COMPTROLLER GENERAL OF THE STATE PROJECT AND ENVIRONMENTAL AUDIT MANAGEMENT DIAPA-D002-2009 COMPAÑIA HIDROPASTAZA S.A.

REPORT OF INDICATIONS OF CRIMINAL LIABILITY

TO THE ADDENDA ENTERED INTO BETWEEN HIDROPASTAZA AND THE ODEBRECHT

CONSORTIUM -VA TECH, ARISING FROM THE CONSTRUCTION CONTRACT FOR THE SAN

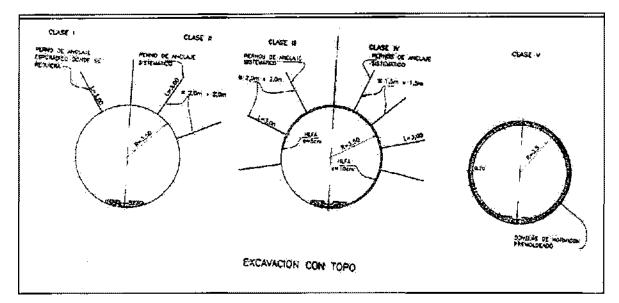
In Volume 3 of the civil works specifications, paragraph 4.12, "Estimate of support", there is a summary of the types of support specified for the headrace tunnel, which are as follows

Percentage of Length			
Classification according to Report	Appendix 6 of the INECEL Final					
ZONE	TUNNEL	Class 1	Class 2	Class 3	Class 4	
HEADRACE TUNNEL	HEADRACE TUNNEL (Conventional Method) Pk 0+000 - Pk 0+090	60,00	20,00	20,00		
	HEADRACE TUNNEL (TBM Topo Method) Pk 0+090-Pk 9+830	45,60	28,10	24,10	2,20	
	HEADRACE TUNNEL (Conventional Method) Pk 9+830-Pk 11+099	50,00	20,00	30,00		
CONSTRUCTION WINDOWS	WINDOW N° 4 (Conventional method)	70,00	20,00	8,00	2,00	
UPPER SURGE STACK	BALANCING CHIMNEY SUPERIOR	70,00	20,00	8,00	2,00

In Volume 6, there is a drawing No. SFR-DS8PCE-TC43-02 containing the design of the types of supports and linings to be used in the excavation of the headrace tunnel, being these the following for the section Pk 0+090 to Pk 9+830 excavated with the mole (TBM), which is similar to the one excavated with the conventional method
